# ADDENDUM No. 1

ITB No. 4565

## Longshore, Indianola, Ottawa, Argo, Amherst Water Main Replacement Project

SCALE: NTS  
DRAWING No. 2018019-5  
SHEET No.

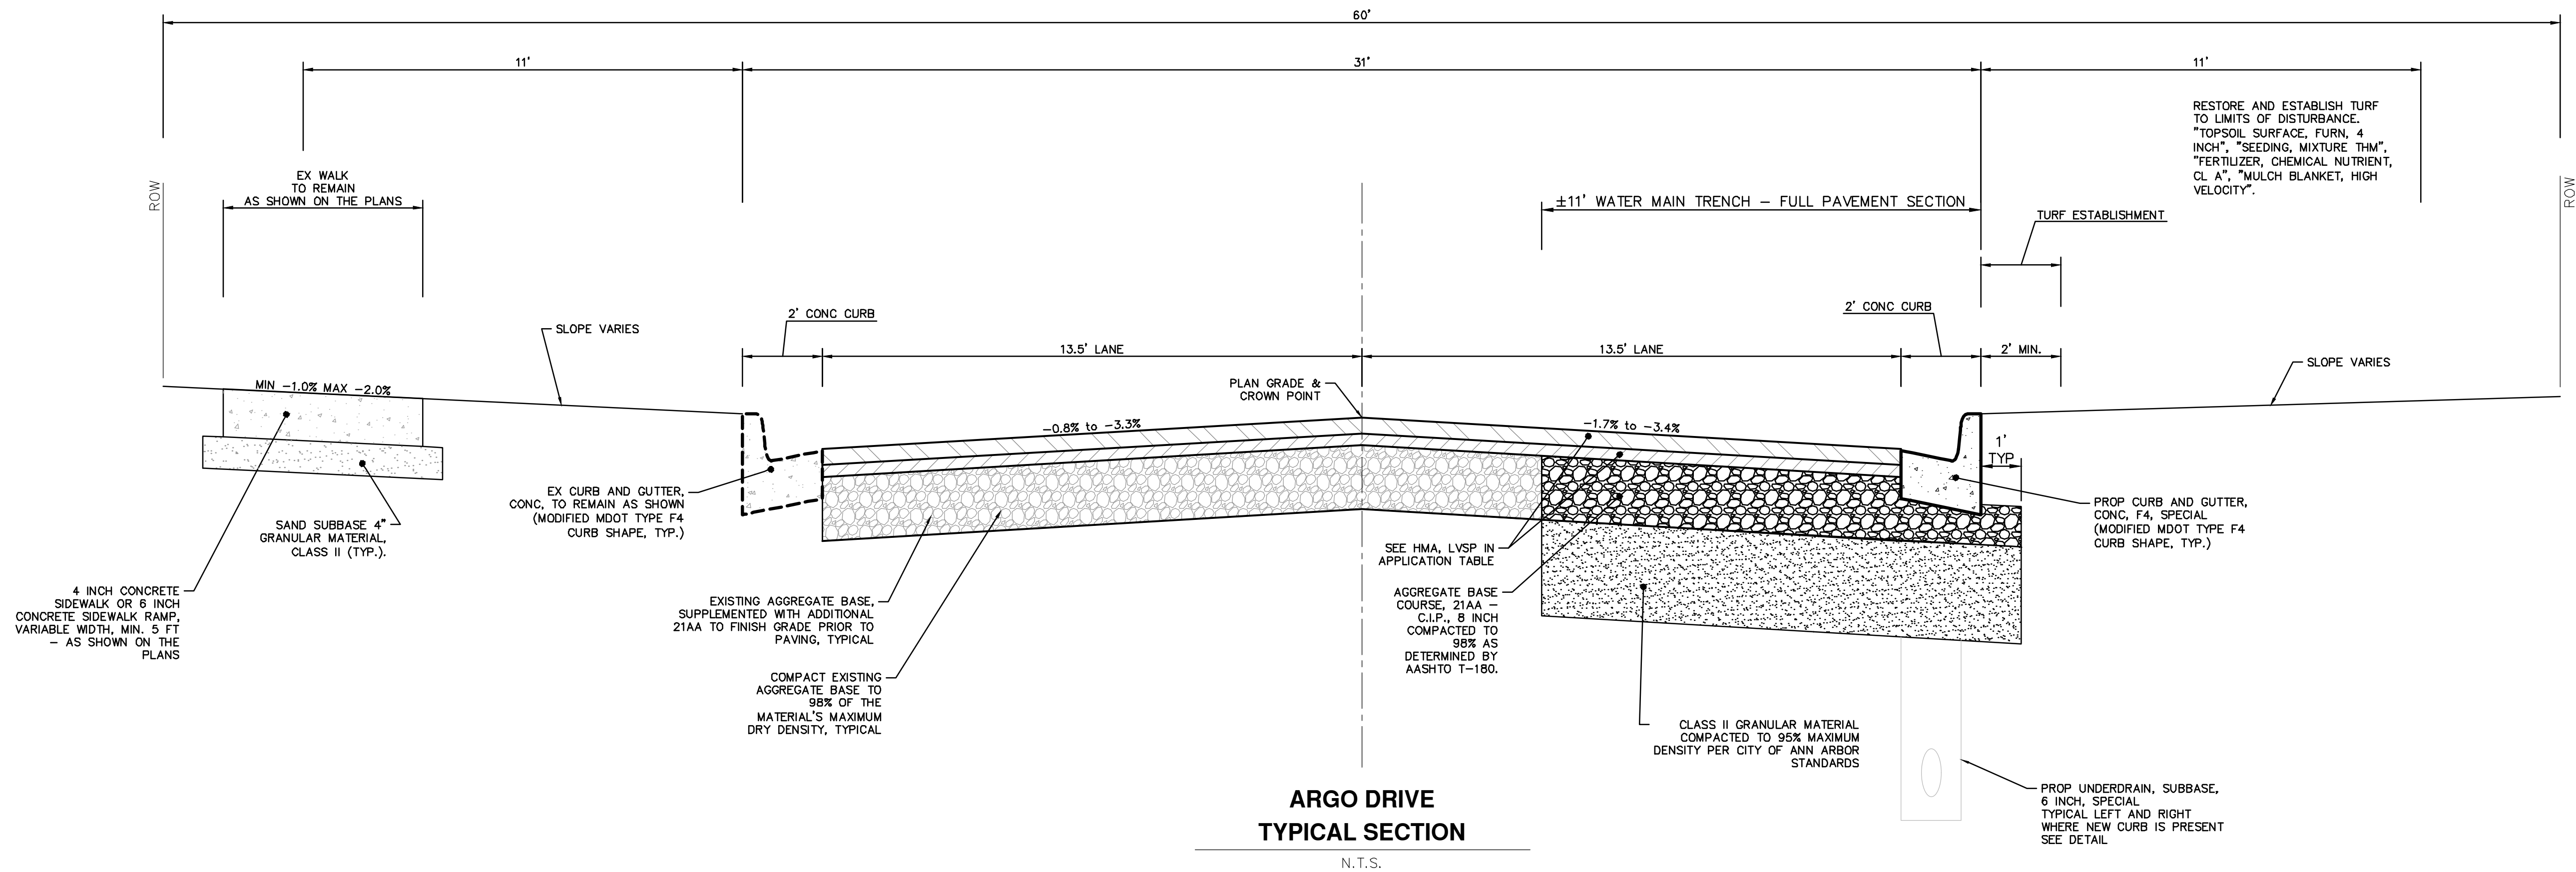
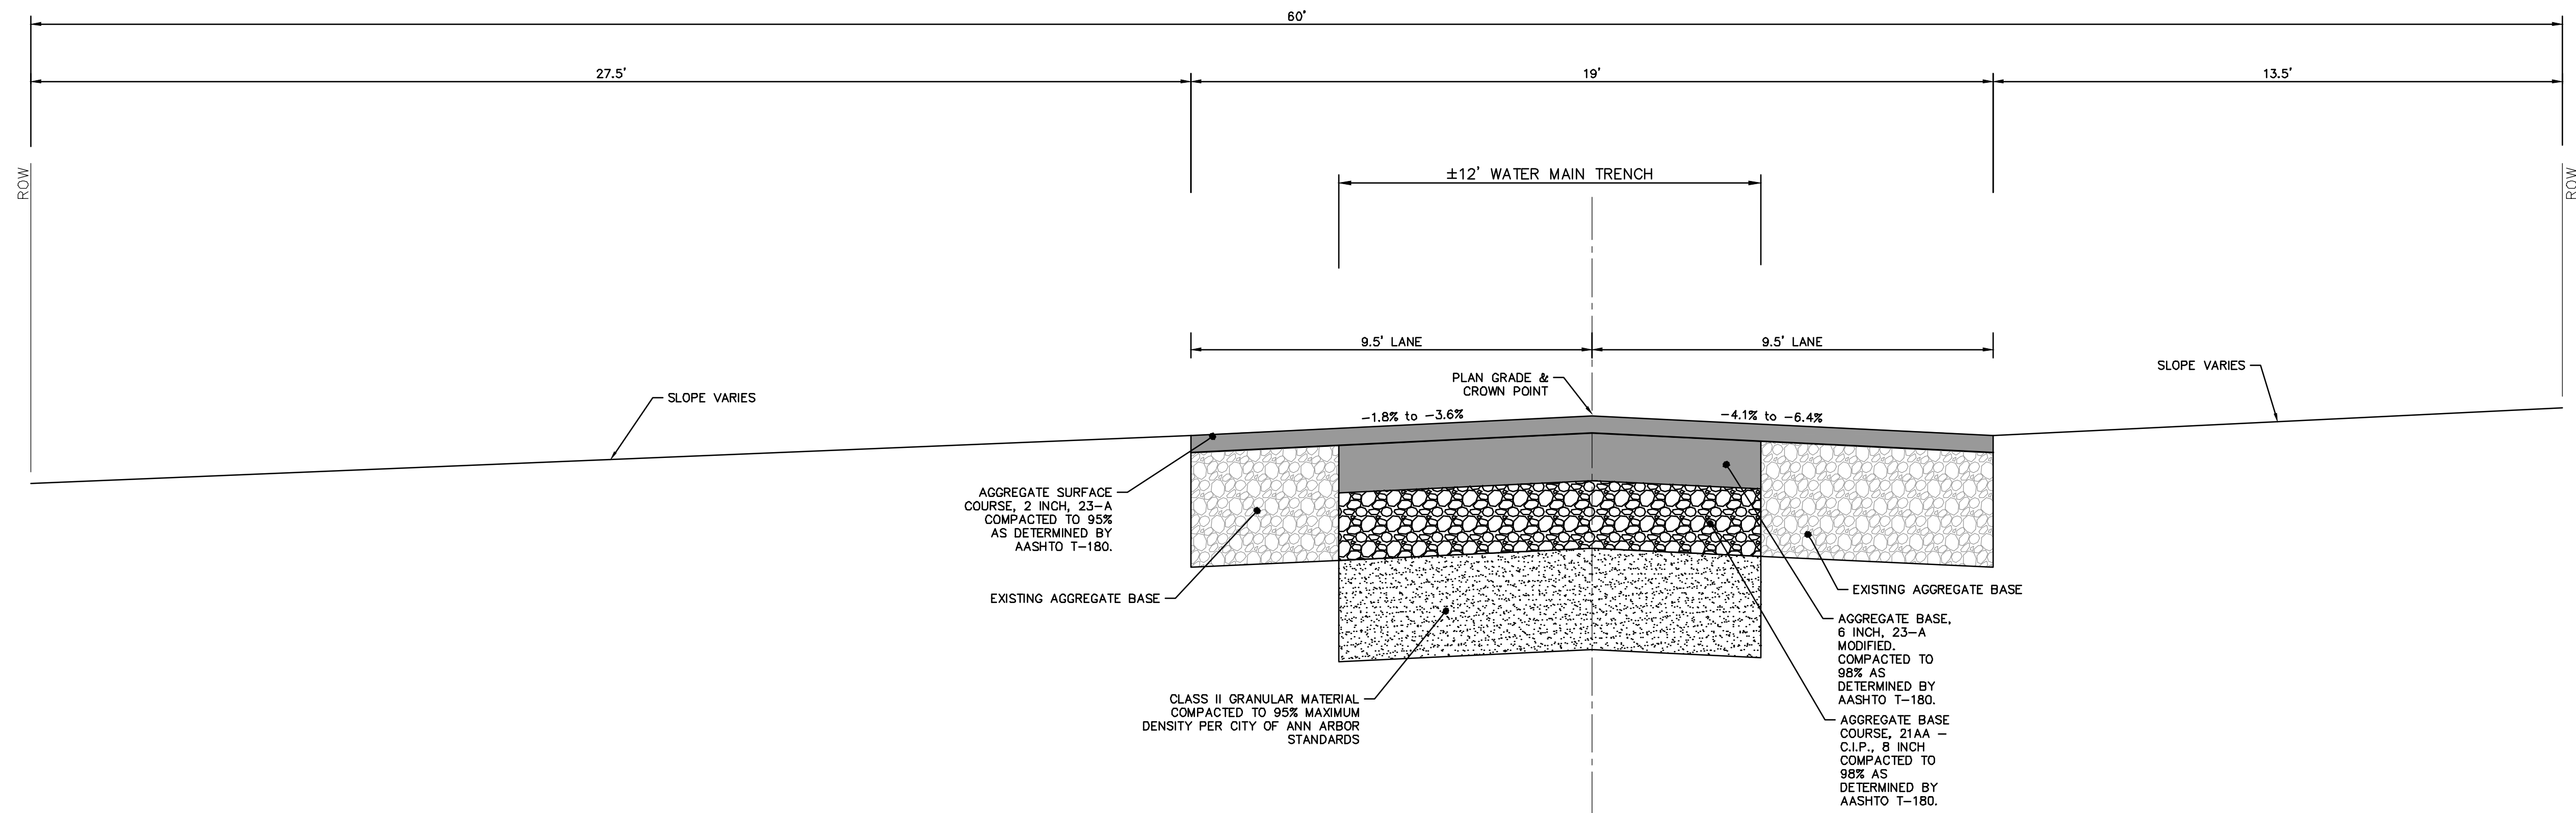
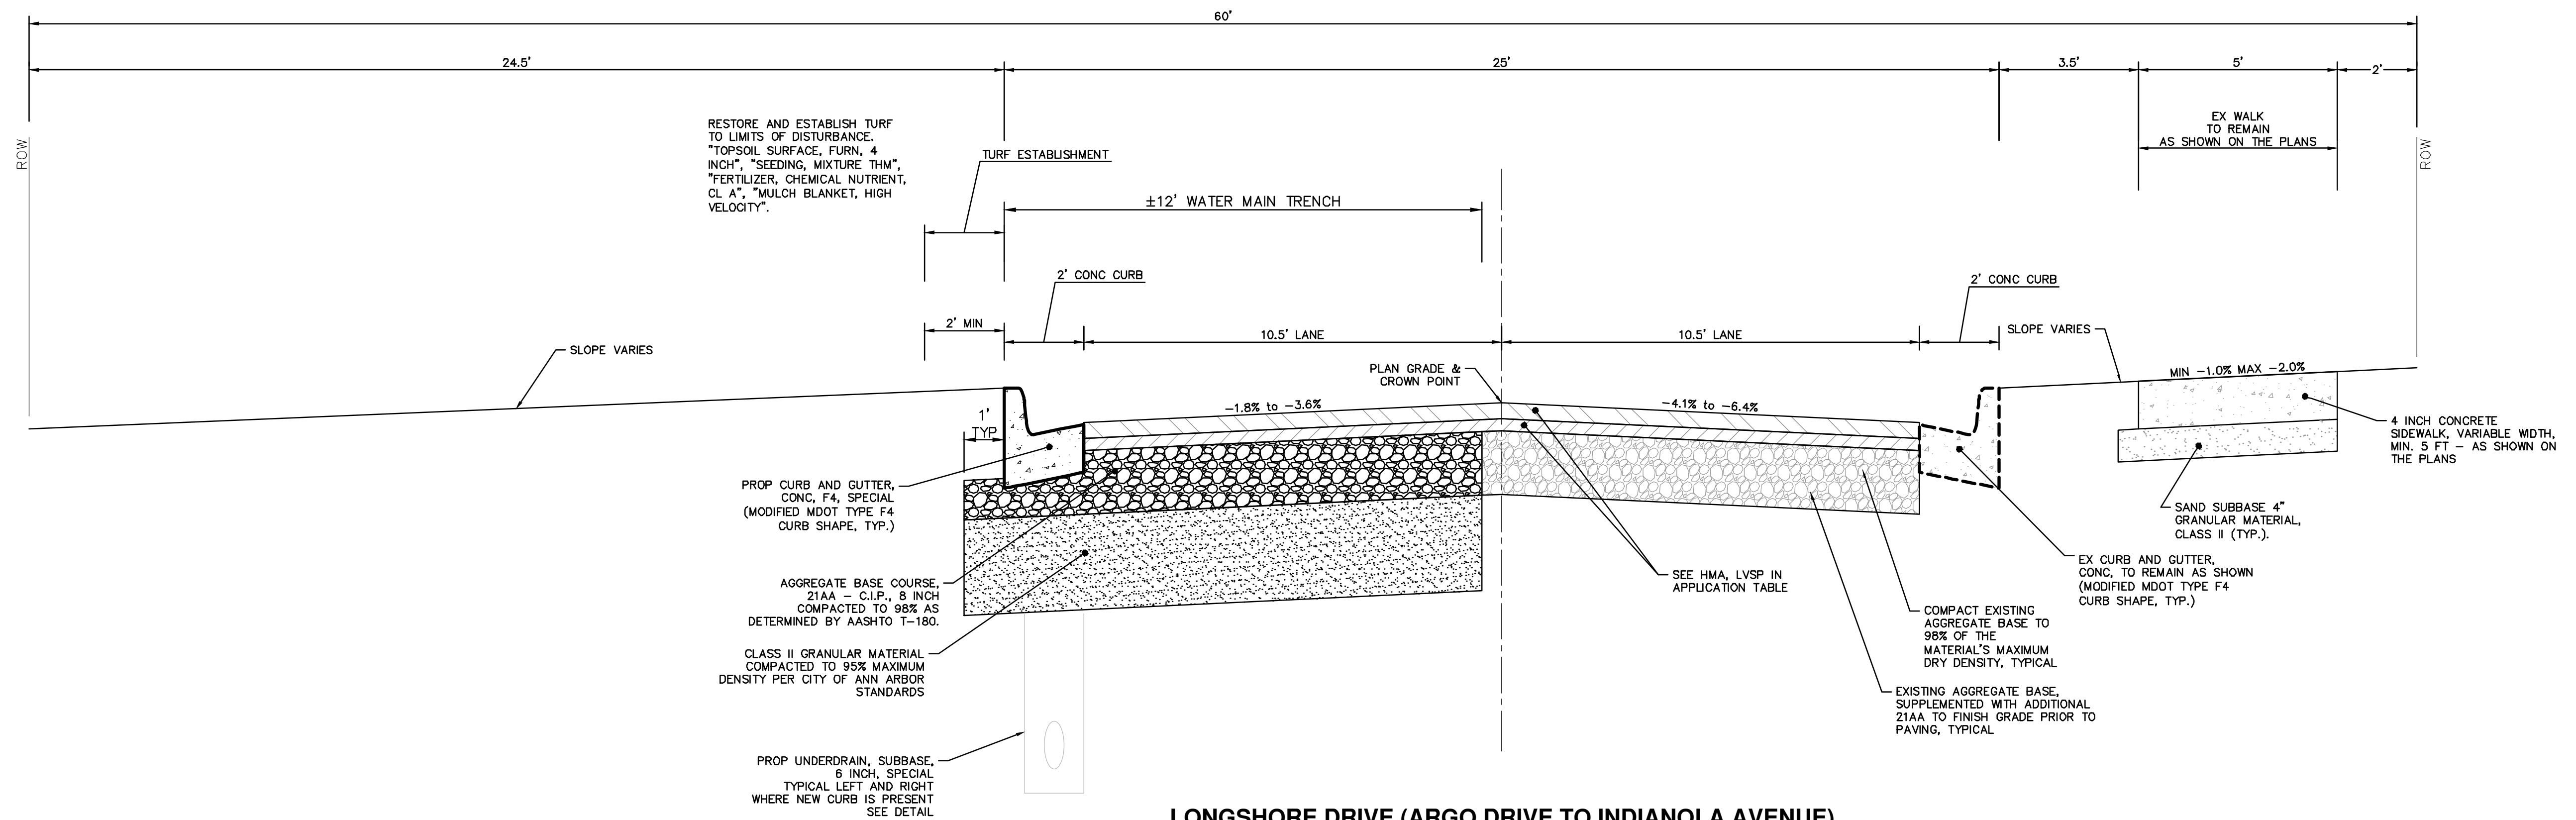
Plan Sheets 4-6 were updated to clarify the pay items and construction methods being used in the Cross-Sections.
